TECHNICAL REVIEW - RESIDENTIAL BUILDING

FOUNDATION LETTER

THE SANCTUARY AT BROOKS PROTOTYPE DUPLX SAN ANTONIO, TEXAS

SHEET: S-1 OF 7

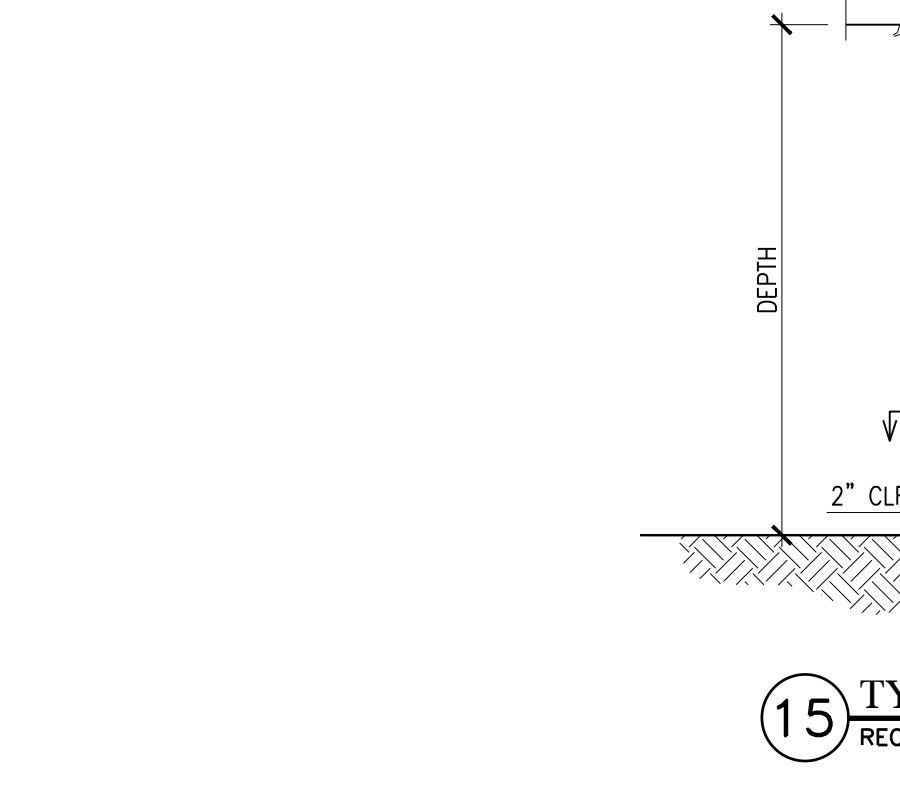
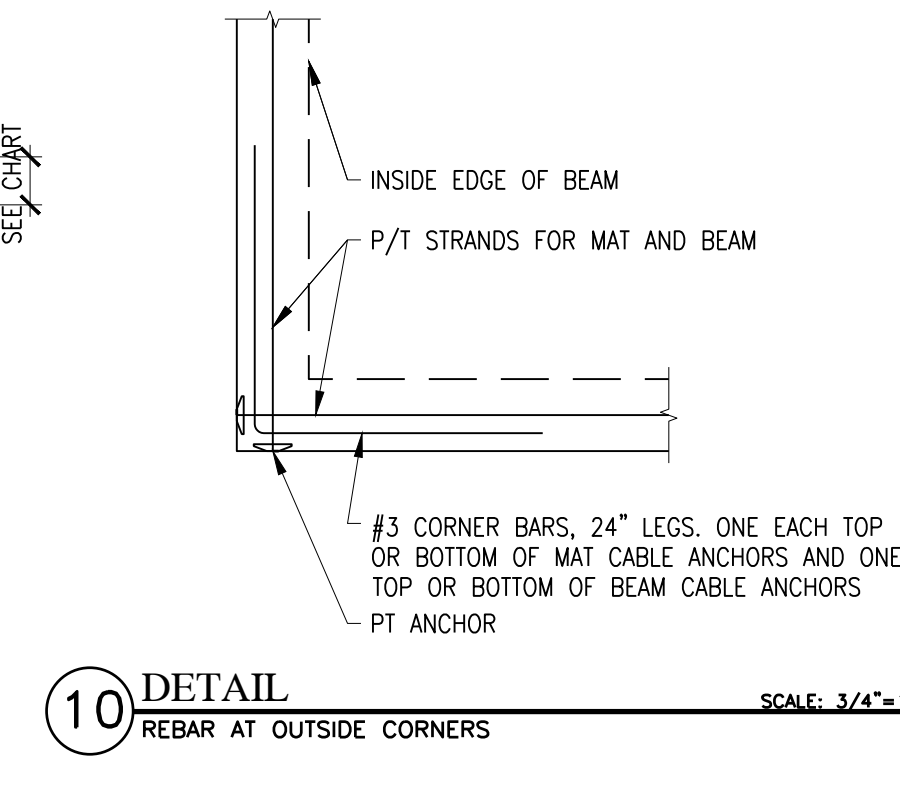
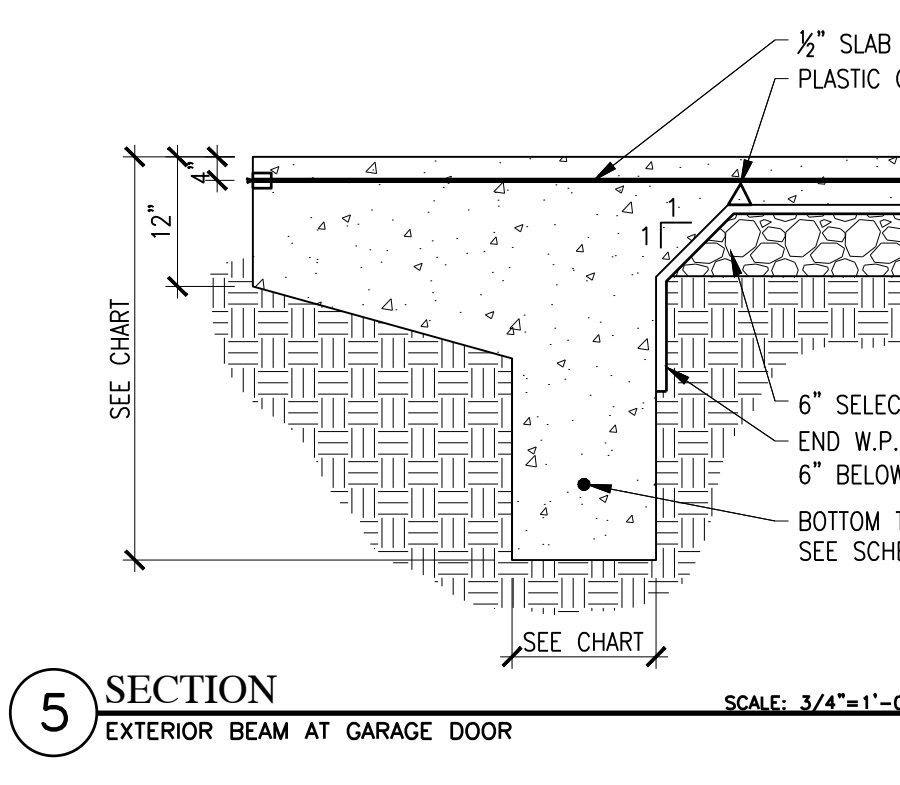
ENGINEERS LETTER REQUIRED FOR SITE SPECIFIC USE OF FOUNDATION DESIGN.

👁️ See: S-2
